International Code Council

ICC 500-2023 edition
Comments on the 1st draft
based on input received
on 2020 edition of the
ICC 500 Standard
9-7-2023

For September, 2023
Meeting – Teleconference

Matrix for ICC 500 Comments

[Figure 306.4.1.1](#)
[Door clearance](#)

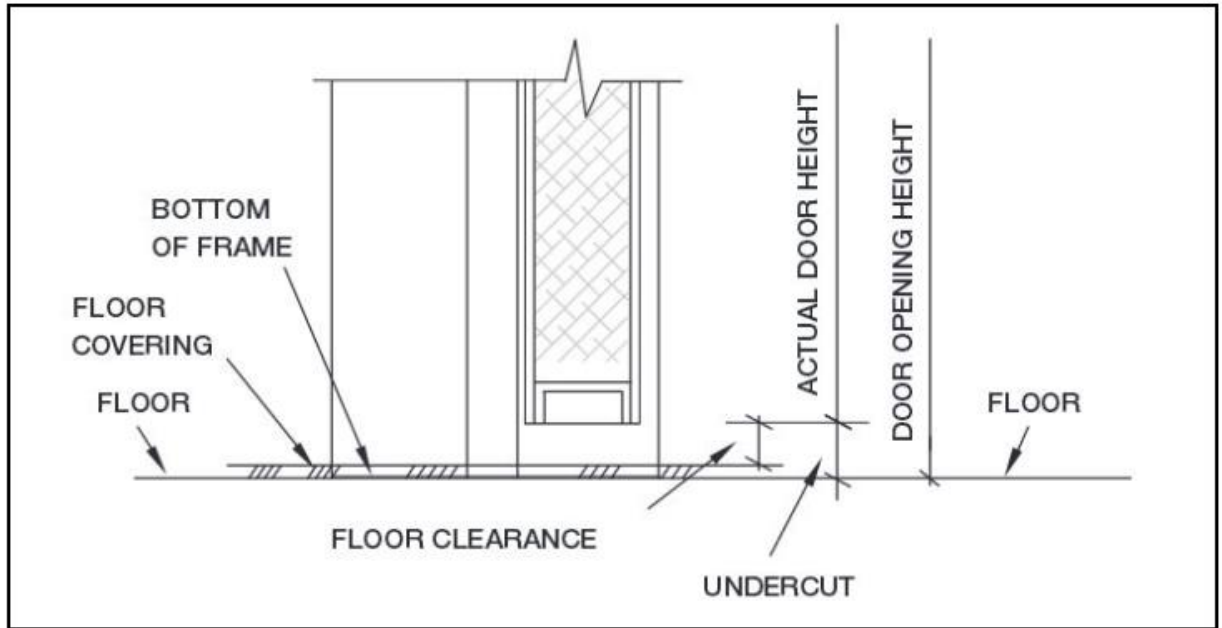
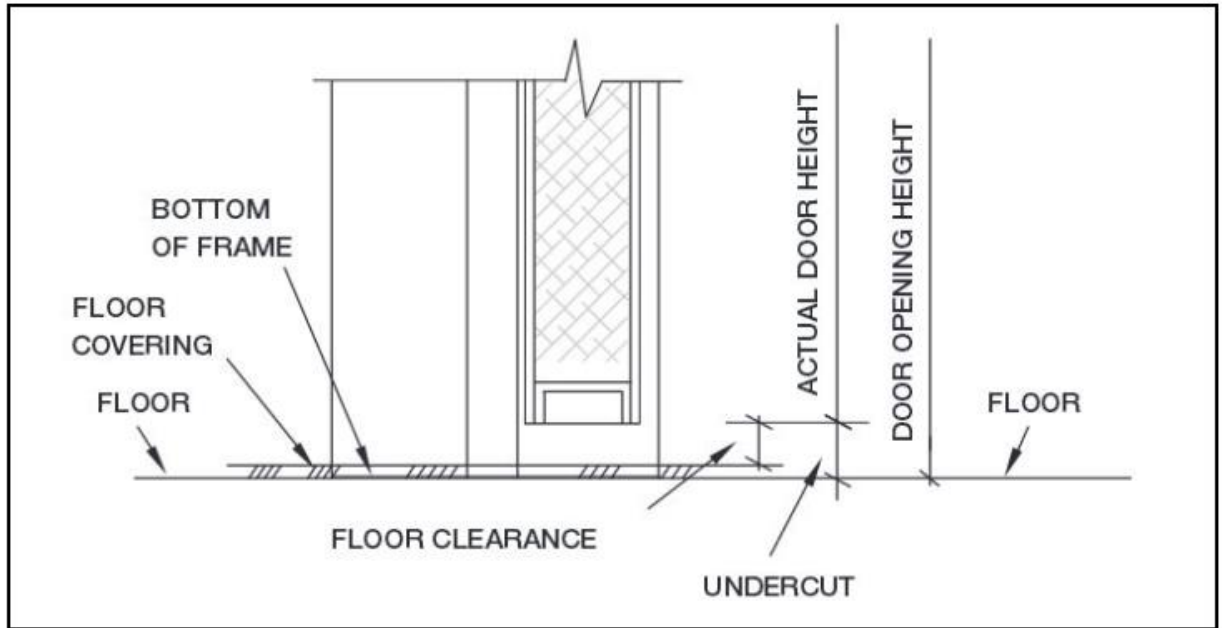
306.4.1.1 Door undercut clearance. Floor clearance for door Door assemblies for use in the storm shelter envelope with a threshold at the level of exit discharge shall be limited to a 3/4-inch (19.1 mm) maximum, undercut measured from the top of the threshold or finished floor. (See example in Figure 306.4.1.1).

Additional criteria may be needed for the bottom edge of sectional or rolling doors later, but there is no guidance right now for what that should be. So this proposal is keeping this general for all doors until that is determined.

306.4.1.1 Door undercut clearance. Floor clearance for door Door assemblies for use in the storm shelter envelope with a threshold at the level of exit discharge shall be limited to a 3/4-inch (19.1 mm) maximum, undercut measured from the top of the threshold or finished floor. (See example in Figure 306.4.1.1).

Figure 803.9.6(3) LOUVER IMPACT TOLERANCE

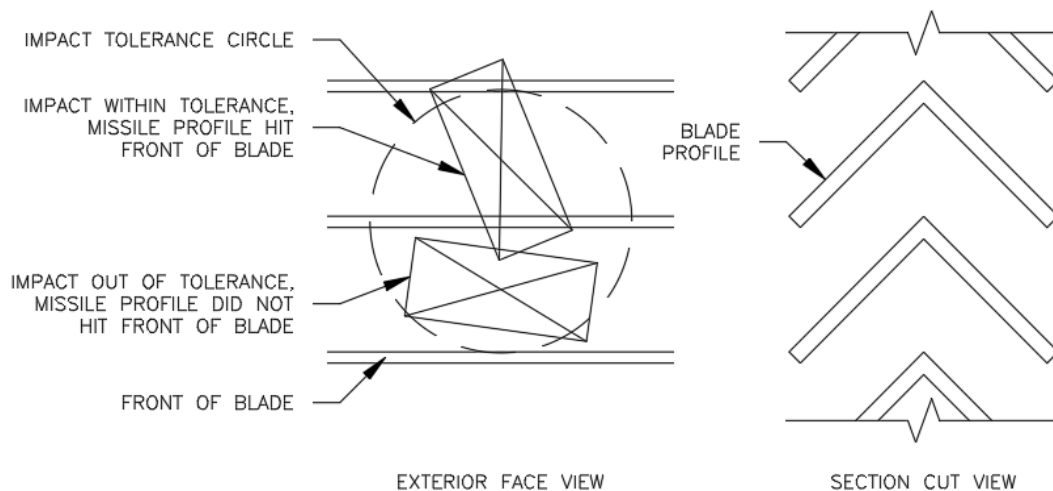
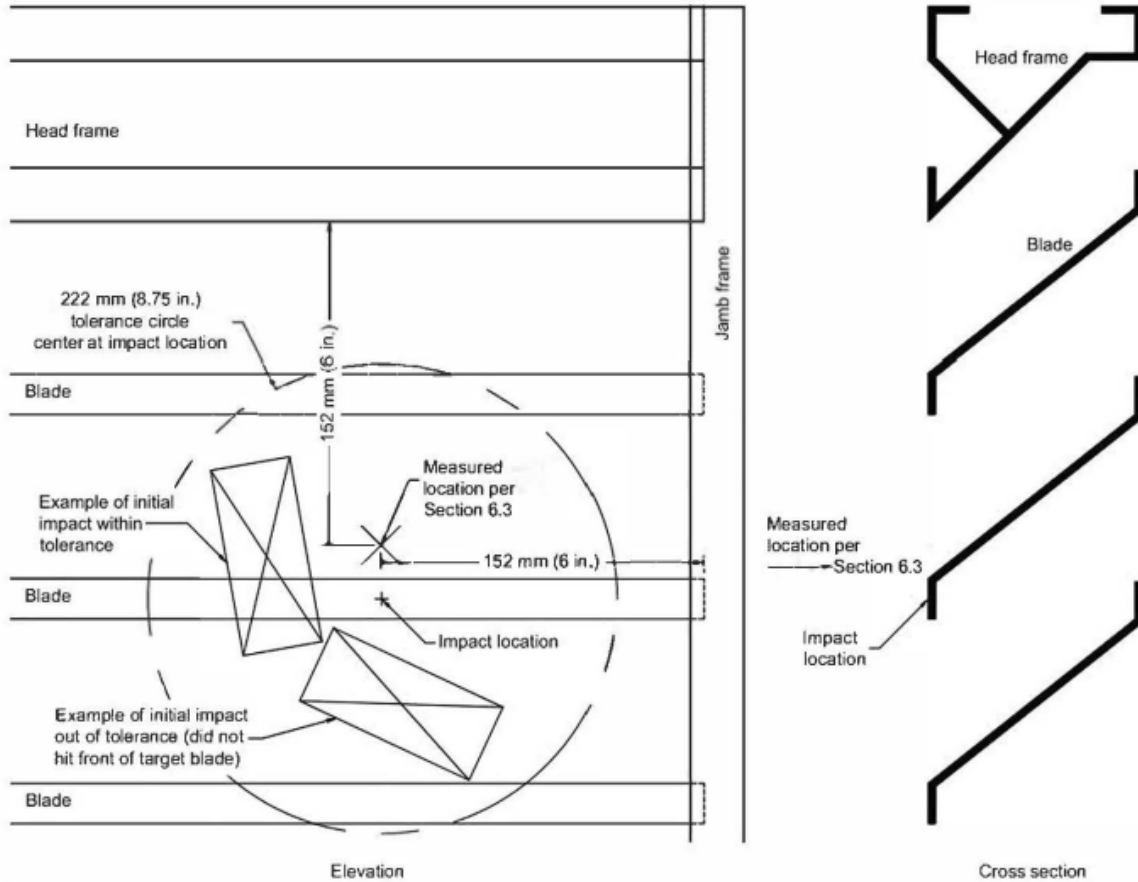
Louvers shall be additionally impacted at mid-span of the blade's longest free-span of each test specimen and the impact shall be permitted be non-centered when measured perpendicular to the blade span. Where an impact location is on the blade of a louver, the leading face of the test missile shall impact the exterior face or edge of at least one blade prior to proceeding deeper into the louver (see Figure 803.9.6(3) for an example).

Reason: First sentence: Due to the draft's new section 306.4.1.5 "Louvers" and its test requirements for louvers to be tested per the IPS section, the IPS impact section needs to add a vulnerable impact location of a louver, which is at mid-span of the louver blade's free span. This is similar to impacting at the center of a glazed opening (required in section 803.9.5) and impacting centered between wall supports (required in section 803.9.1).

Was added to reincorporate a small portion of a disapproved proposal of an entire new section regarding louver specific test requirements (IS-STM 08-08-23). Now being proposed is only a single sentence instead of an entire new section. The sentence was modified from the original IS-STM 08-08-23 proposal. The sentence ensures the missile makes initial impact on the front of a louver blade, which prevents an impact failure due to the test missile sneaking between two blades and making first impact at a location mid-depth within the louver. Similar language is in AMCA Standard 540, "Test Method for Louvers Impacted by Wind Borne Debris", which has been accepted by Miami-Dade County, the Florida Building Code, and the IBC. A new figure is proposed to assist in the understanding, which is modified from a figure in AMCA 540 (shown below).

Figure 803.9.6(3) LOUVER IMPACT TOLERANCE

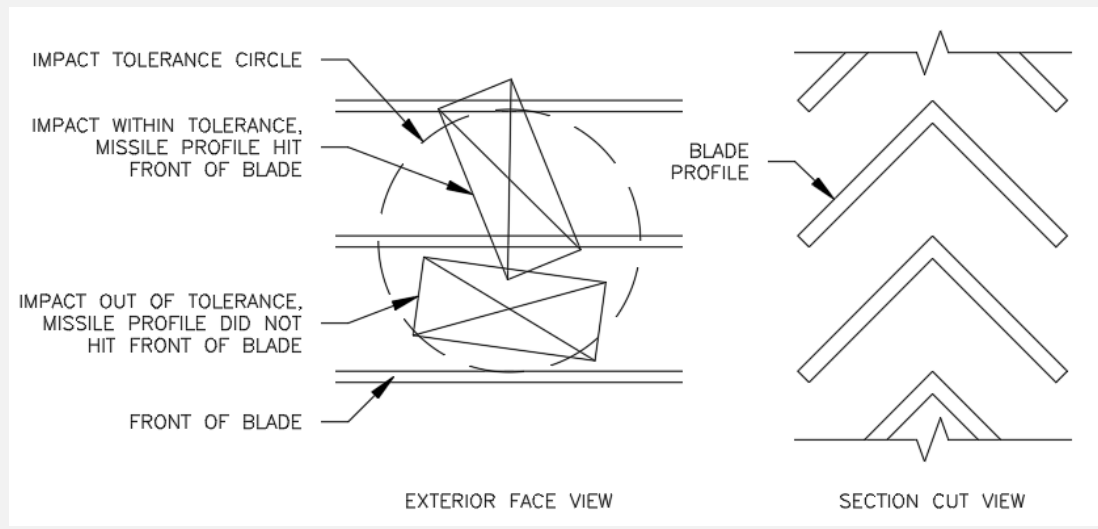
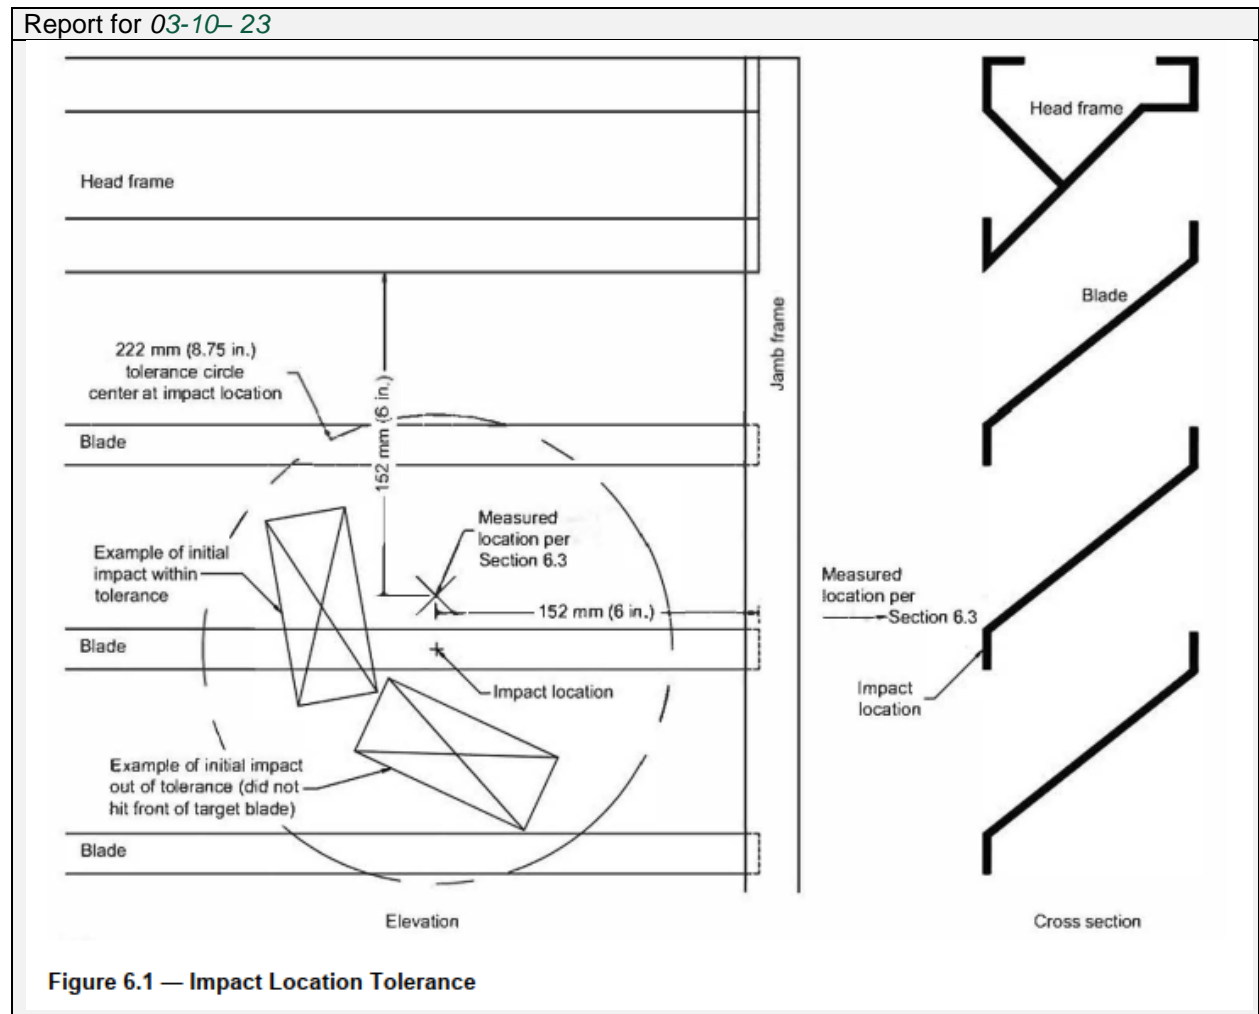
Louvers shall be additionally impacted at mid-span of the blade's longest free-span of each test specimen and the impact shall be permitted be non-centered when measured perpendicular to the blade span. Where an impact location is on the blade of a louver, the leading face of the test missile shall impact the exterior face or edge of at least one blade prior to proceeding deeper into the louver (see Figure 803.9.6(3) for an example).

Reason: First sentence: Due to the draft's new section 306.4.1.5 "Louvers" and its test requirements for louvers to be tested per the IPS section, the IPS impact section needs to add a vulnerable impact location of a louver, which is at mid-span of the louver blade's free span. This is similar to impacting at the center of a glazed opening (required in section 803.9.5) and impacting centered between wall supports (required in section 803.9.1).

Was added to reincorporate a small portion of a disapproved proposal of an entire new section regarding louver specific test requirements (IS-STM 08-08-23). Now being proposed is only a single sentence instead of an entire new section. The sentence was modified from the original IS-STM 08-08-23 proposal. The sentence ensures the missile makes initial impact on the front of a louver blade, which prevents an impact failure due to the test missile sneaking between two blades and making first impact at a location mid-depth within the louver. Similar language is in AMCA Standard 540, "Test Method for Louvers Impacted by Wind Borne Debris", which has been accepted by Miami-Dade County, the Florida Building Code, and the IBC. A new figure is proposed to assist in the understanding, which is modified from a figure in AMCA 540 (shown below).

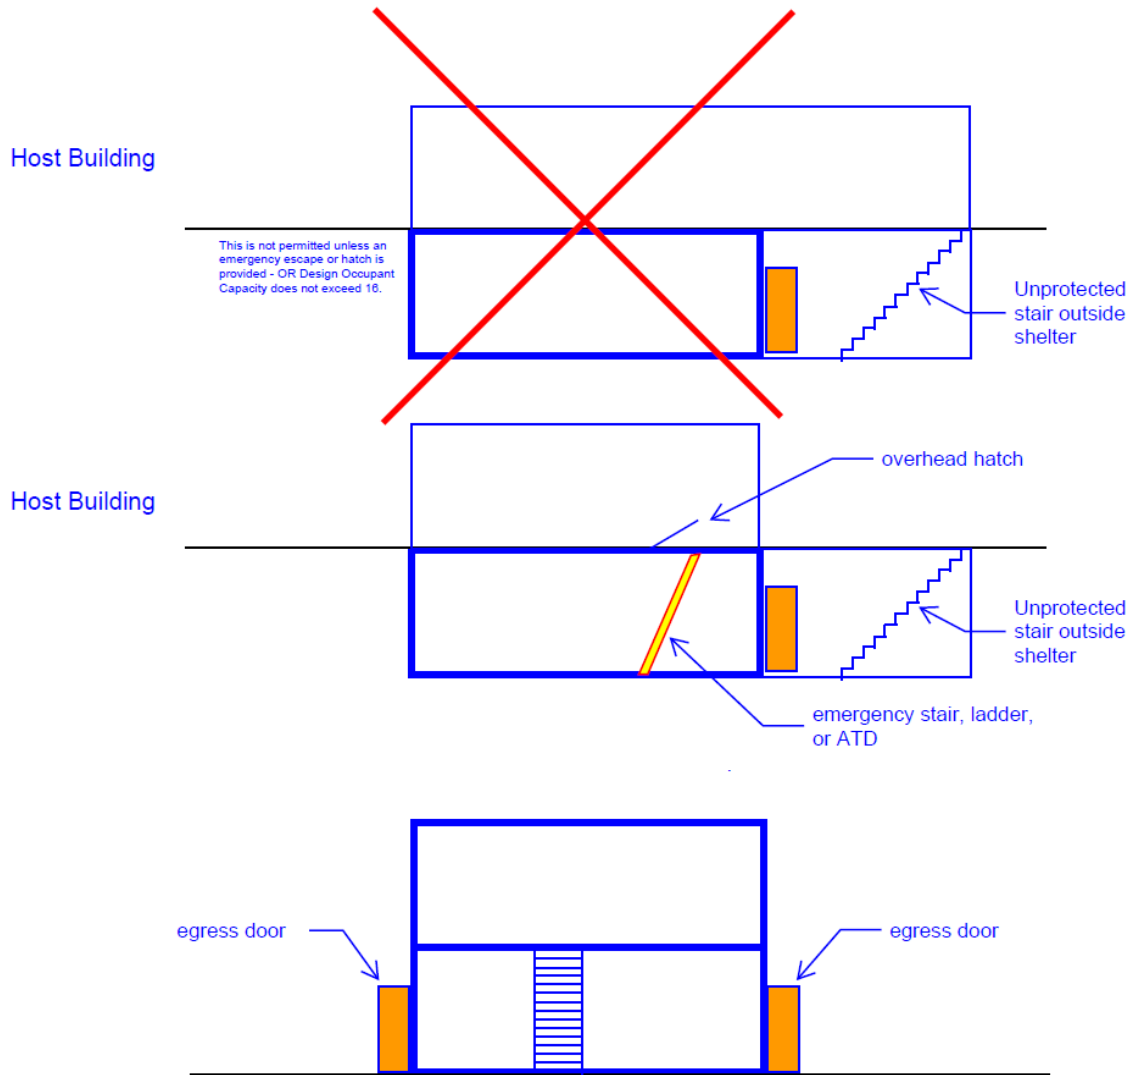
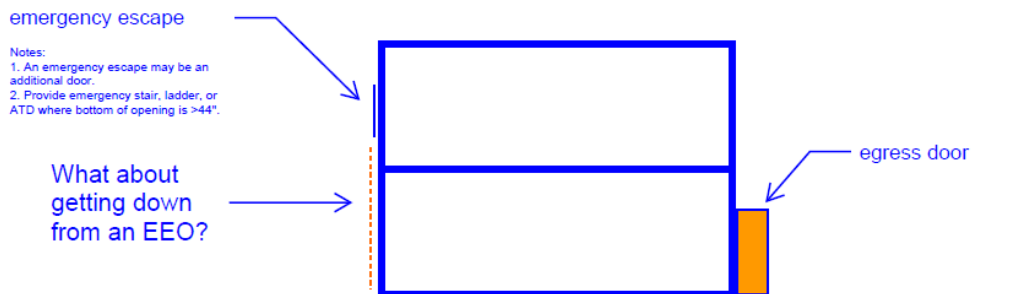
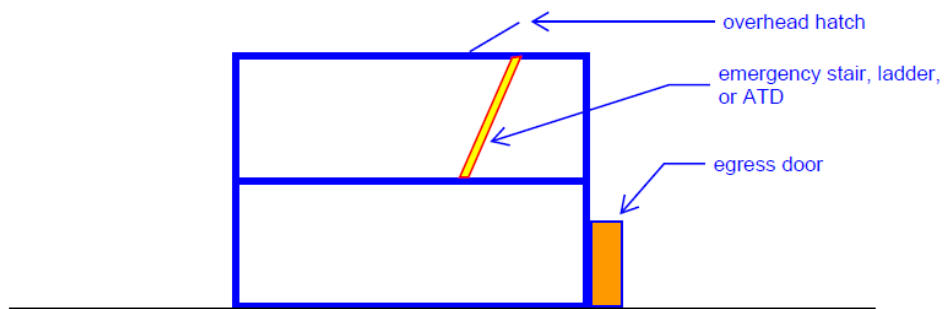
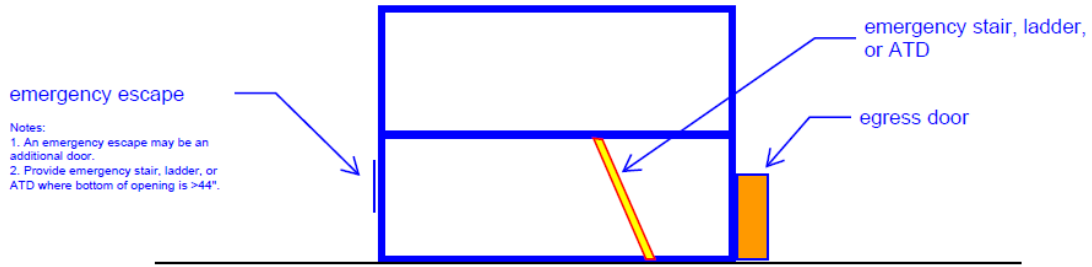
Committee Reason: The purpose of this requirement is to minimize the chance of entrapment due to falling debris or access to the exit stairways within the building being unavailable. This encompasses basements and 2nd story levels of shelters.

The following diagrams were shown during the meeting to explain the change.

FIGURE 803.9.4.3 SECTIONAL DOOR ASSEMBLIES

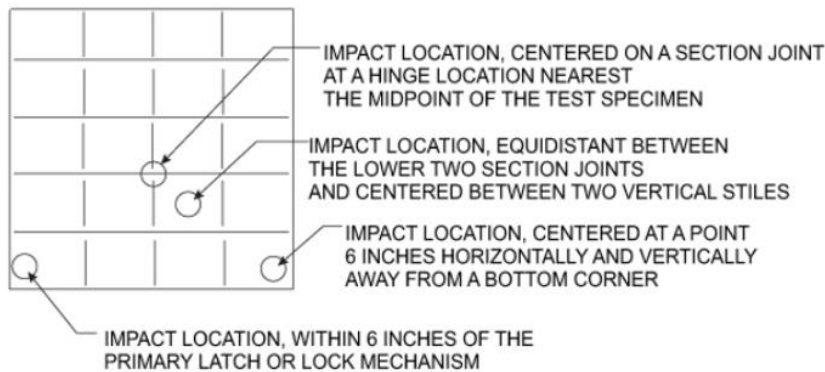
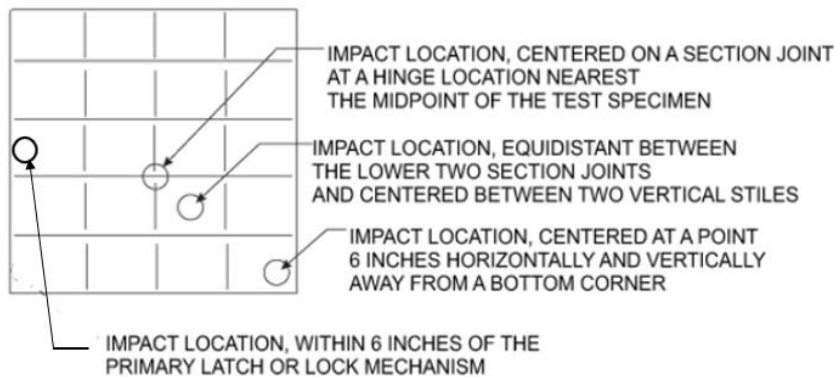
803.9.4.3 Sectional door assemblies. For sectional door assemblies, the door shall be impacted centered on a section joint at a hinge location nearest the midpoint of the test specimen, equidistant between the lower two section joints and centered between two vertical stiles, centered at a point 6 inches horizontally and vertically away from a at one bottom corner, and within 6 inches (152 mm) of the primary latch or lock mechanism as shown. See example in Figure 803.9.4.3.

Reason: Cleanup and clarity of text to align with Figure. There should not be variation in the text between the section language and the figure.

FIGURE 803.9.5(1)
WINDOW ASSEMBLIES AND OTHER GLAZED OPENINGS

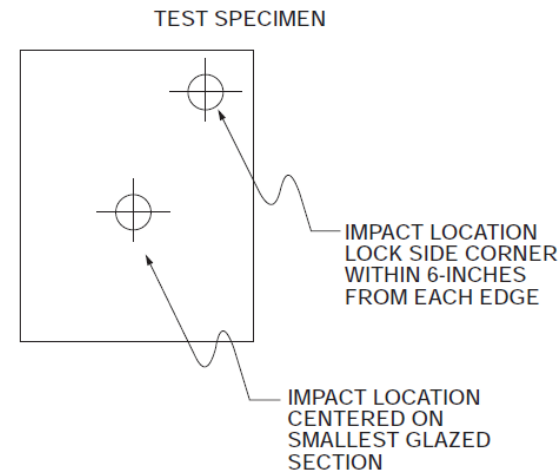
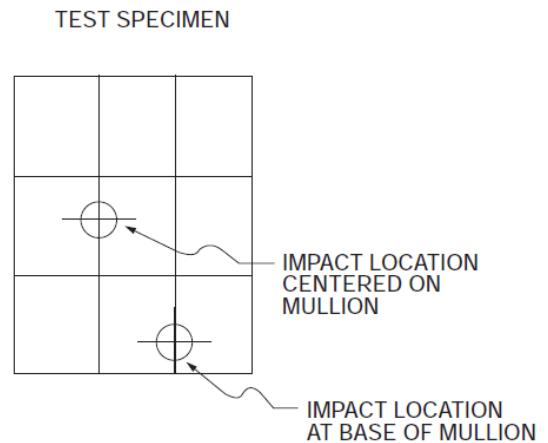
Modify figure 803.9.5(1) to include 'one interface corner' in note

803.9.5 Window assemblies and other glazed openings. All window assemblies and other glazed openings shall be impacted in the center of the smallest glazed section, and at ~~the lock side corner, or one interface corner, a corner~~ within 6 inches from each edge. Where a lock/latch is provided on the test specimen, the corner impact shall occur nearest the lock/latch. as applicable as detailed See example in Figure 803.9.5(1). Where interior mullions or other glazed section joints are present, the assembly shall be impacted centered on the mullion and at base of mullion as shown in Figure 803.9.5(2). Interface hinge joints and primary latches, where present, shall be impacted as shown in Figure 803.9.4.1(2) on an additional specimen.

FIGURE 803.9.2(1)
SOLID WALL ASSEMBLIES AND ROOF ASSEMBLIES
OF CONCRETE OR OTHER MATERIALS

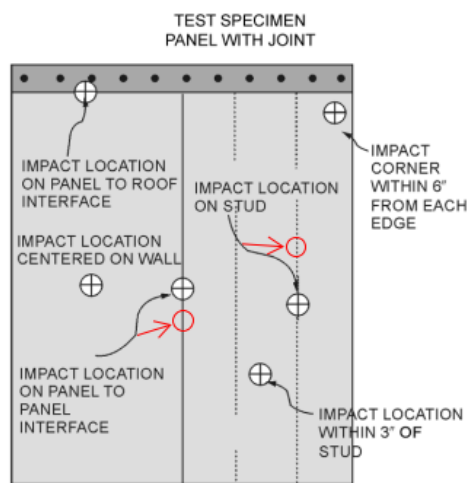
Added a sentence to clarify in text and to match figures 803.9.2(1) and 803.9.2(2) that the support impacts can be off-center.

Figures 803.9.2(1) and 803.9.2(2) are updated to better show that impacts do not need to be horizontally in line with each other.

FIGURE 803.9.2(1)
SOLID WALL ASSEMBLIES AND ROOF ASSEMBLIES
OF CONCRETE OR OTHER MATERIALS

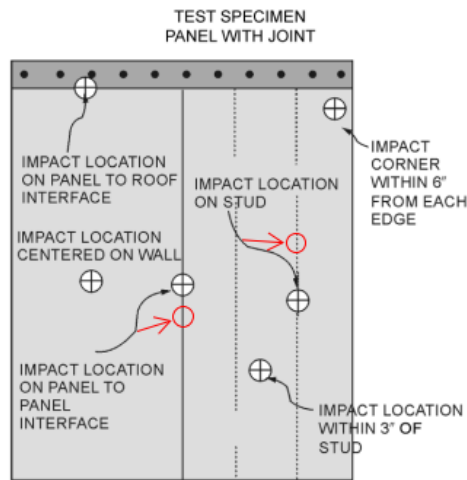
Added a sentence to clarify in text and to match figures 803.9.2(1) and 803.9.2(2) that the support impacts can be off-center.

Figures 803.9.2(1) and 803.9.2(2) are updated to better show that impacts do not need to be horizontally in line with each other.
